TENNESSEE VALLEY AUTHORITY

May 24, 1984

RESPONSE - NRC INSPECTION REPORT NOS.
50-259/84-11, 50-260/84-11, AND 50-296/84-11
RICHARD C. LEWIS'S LETTER TO H. G. PARRIS
DATED APRIL 27, 1984

259, 260, 296/84-11-01

- ATTACHMENT III -

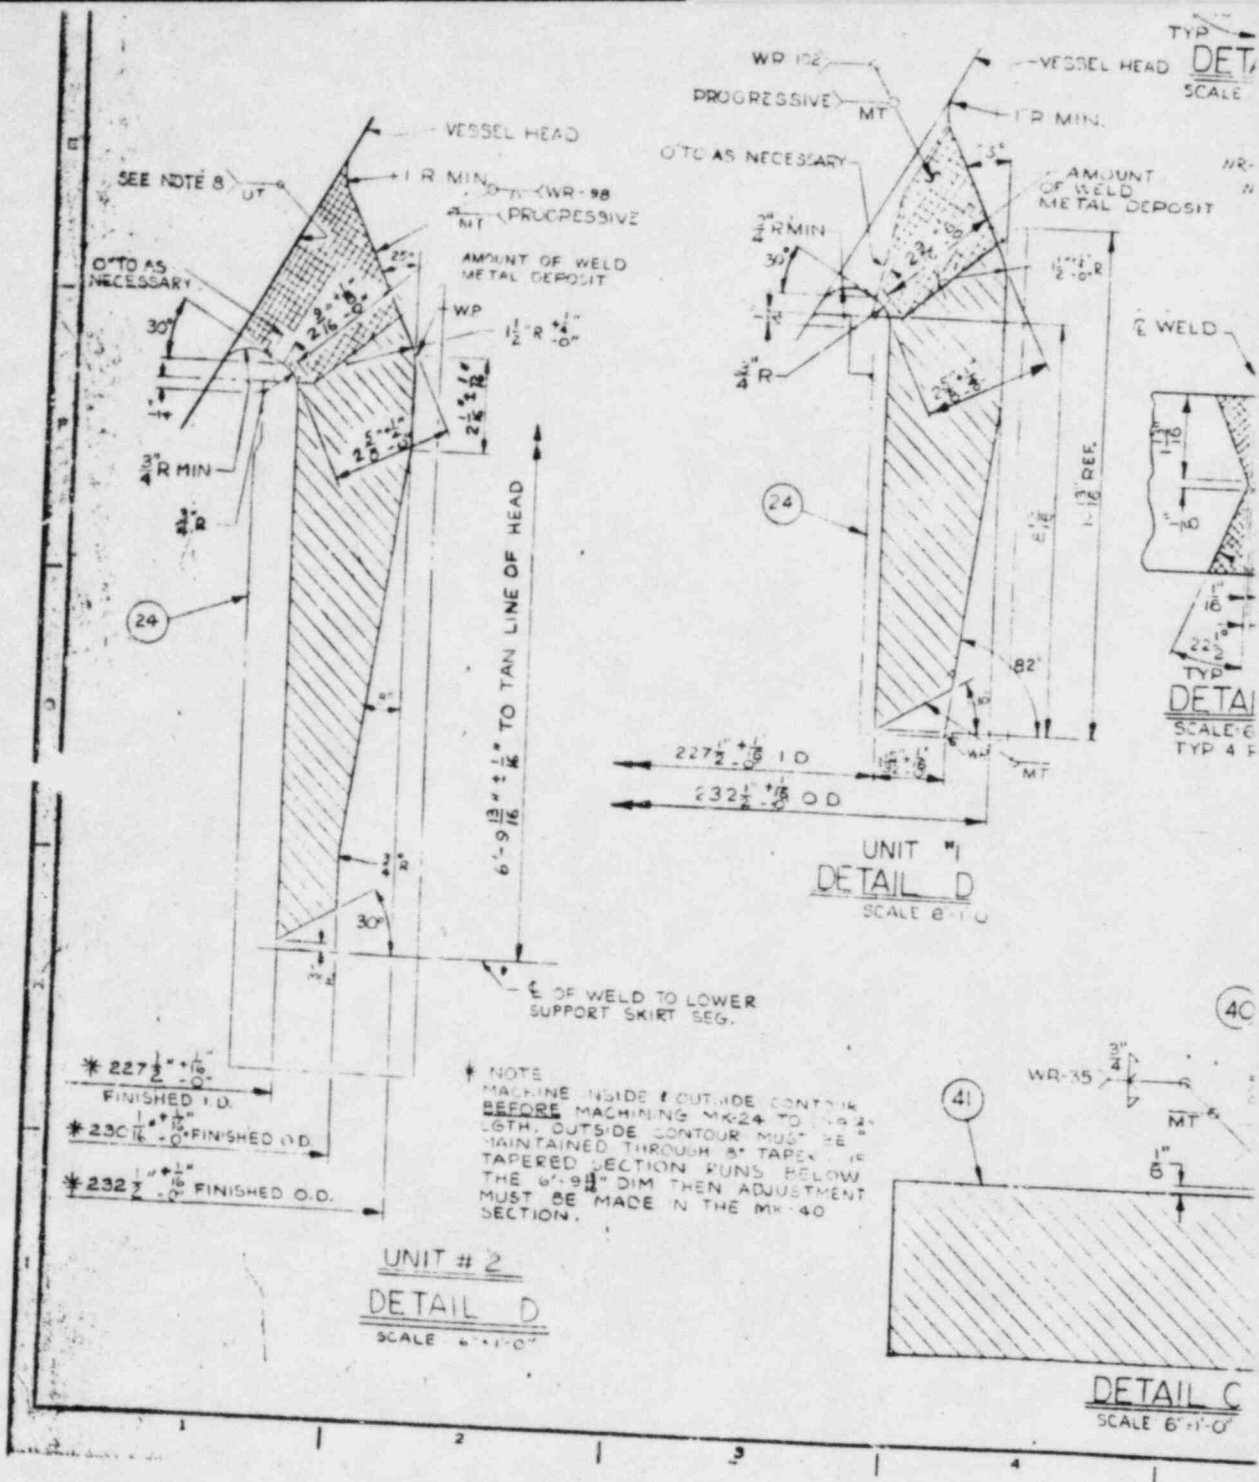
- b. A copy of the manufacturer's fabrication drawing is included as Attachment III. Review of Detail D of this drawing indicates the weld and adjacent base material are approximately 2-1/2 inches thick. The base material thickness then decreases approximately 1/8 inch per inch as the measurement point is moved downwards away from the weld. It is likely the measurement recorded on the examination report was taken in the tapered area rather than adjacent to the weld, resulting in a smaller reading. While there is no requirement to make the thickness measurement, the examination report as written now is not clear and subject to question. TVA will therefore add an inspection to the in-service inspection plan for the next scheduled outage to recheck the wall thickness adjacent to the weld. If the wall thickness is verified

to be as shown on the drawing, the examination report will be corrected. If the wall thickness is found to be too thin for the calibration block used, a reexamination using the correct calibration block will be performed. These corrective steps should be completed by February 1985.
